Access Compliance Report

Public Rights-of-Way

(Pedestrian Signals)

Intersection ID: N/A	Main Street:	Cross Street: N/A	Location: N/A
ADA ID: 4FE36C5606A8	Signal Type: One Push Button-Non APS	Overall Compliance: No	Severity Score: BTN 1: N/A BTN 2: N/A No BTN: N/A
Codes/Mitigation Info/Possible Solution		Field Measurements/Component Compliance

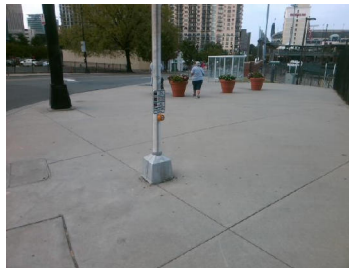
Surveyor Notes: TEXT HT 5/16

PROW/ADA: R410.6, TMUTCD 4e.08, R404.2, R406.2, R104.2, R209.1

Possible Solutions: Replace Signal Push Button With APS Button on New Post. Remove & Replace Sign.
